O	OB WO OZZ PURCHASE ORDER CHANG	04-45618-007
	PROJECT: MODIFY PACKING GLAND	DATE:
	FCO #: 015	PROJECT #: 80960
1	CUSTOMER: IPSC	P.O. #:
	REASON FOR CHANGE:	
	IPSC REQUEST	
T	DESCRIPTION OF CHANGE:	,
E		
1	MODIFY NEW BURNER TO RECEIVE SCANNERS	
_		
P	PEOPLE CONTACTED AND METHODS TAKEN TO	O PESOLVE PROBLEM:

TEI Construction Services, Inc. T&M Billing Cost Summary

PROJECT 80960 CLIENT INTERMOUNTAIN POWER PLANT TEI NO. ORDER NO. EWO NO. 015

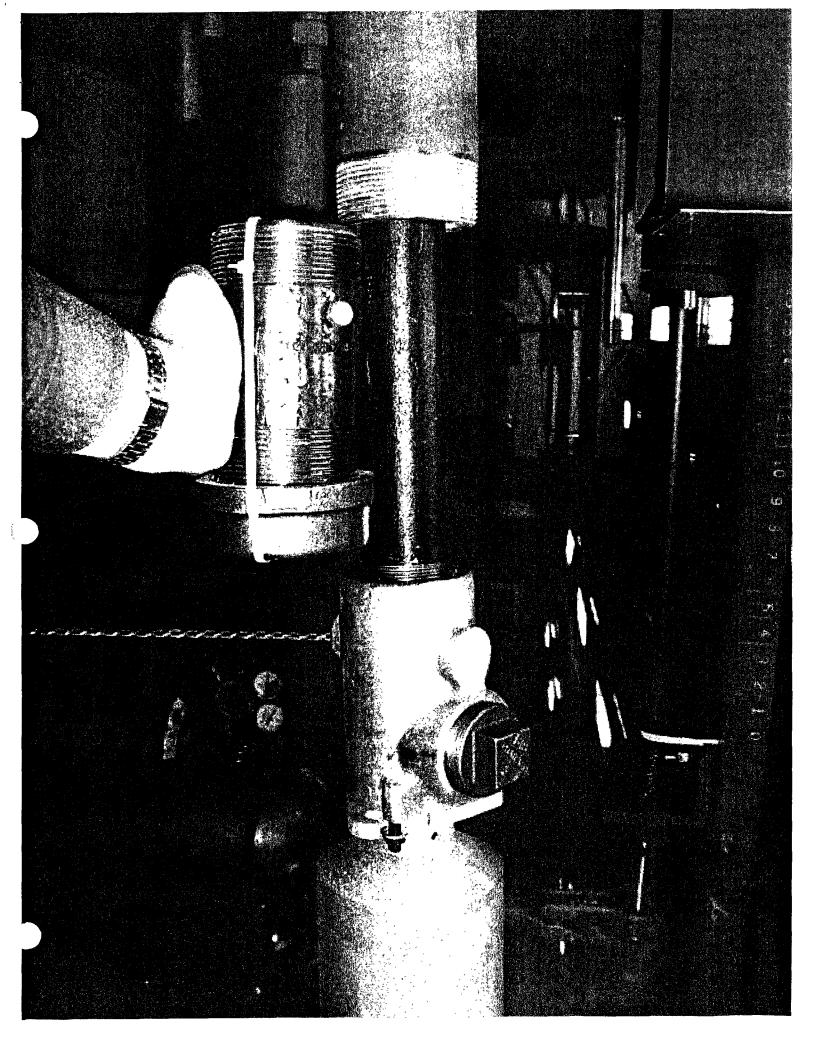
I fouind the flame scanner tube packing glands and tried installing one.

I can't tell which way they are supposed to install. They appear to be missing

a connector or something. If there is a coupler in there then the scanner tip will be about 16 inches back from the turning vanes.

See enclosed photo of the packing gland. Please advise.

You received the entire assembly which typically connects to a three inch female coupling. Since you have a threaded pipe already installed there can be only a few options. Your picture Scanner Packing Gland2 is the correct orientation. One option would be to modify the existing pipe and drill holes for the positioning bolts and place the gland cap and packing on the existing pipe. The other option would be to cut the pipe back on the burner and re-thread and provide a female coupling. The bolts in the packing gland are need to keep the pipe centered and lock it down the packing gland cap and packing material is required to seal the assembly.
